Review of Schaefer et al, The Cryosphere

Review of “Projecting the evolution of the Northern Patagonian Icefield until the year 2200” by Schaefer et al.

Figure 1: Illustration of the ESM model grid cells and NPI extension for two ESMs with different spatial resolution.

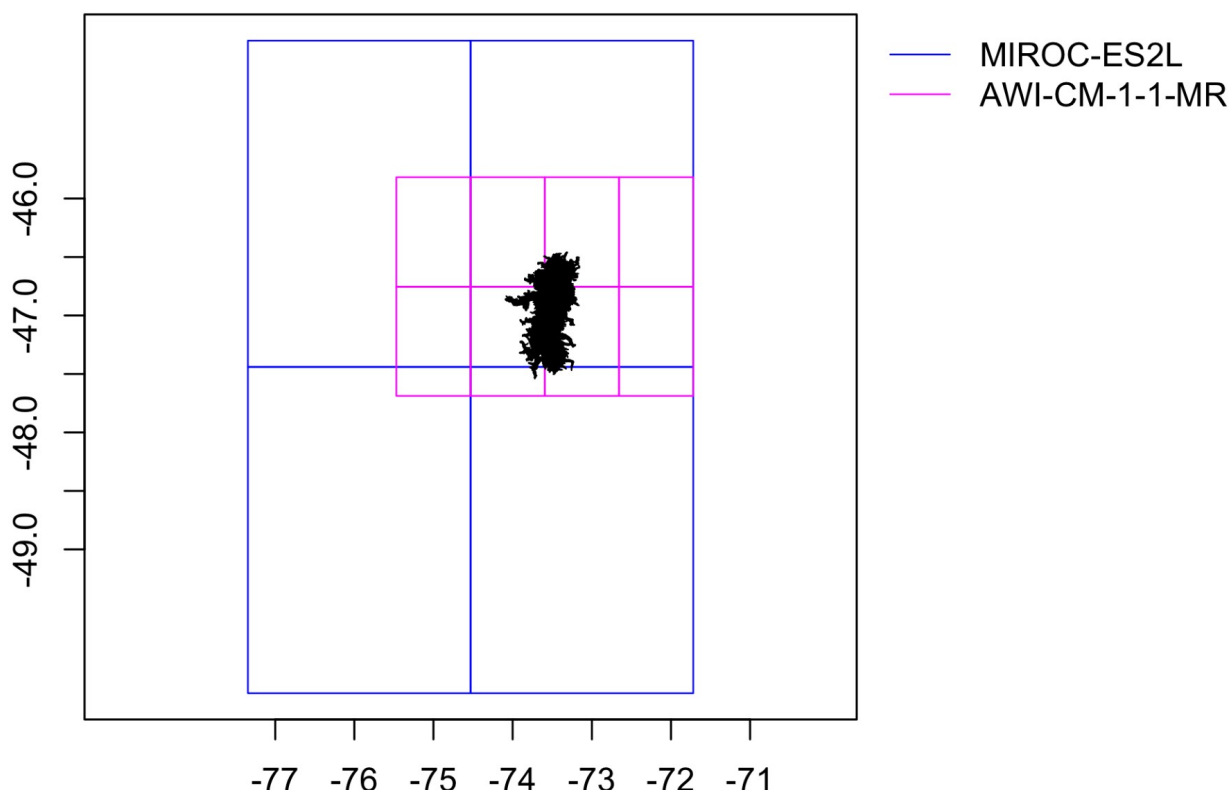
- Spatial patterns present in the ESMs may not be captured with the adopted methodology. I understand that downscaling ESM outputs may be challenging, but acknowledging this limitation would strengthen the discussion.

The spatial patters of the surface mass balance fields stem from Schaefer et al. 2013 , where model parameters were adjusted to represent best the spatial variation of point surface mass balance measurements form the Eastern and Western side of the icefield including two ice-cores from the accumulation area and geodetic mass balances of three not calving glaciers. Since the spatial resolution of ESMs is very low, a maximum of four grid cells was used to infer future

temperature (mean) anomalies (see figure below) We detailed information on model resolution is now given table A1.
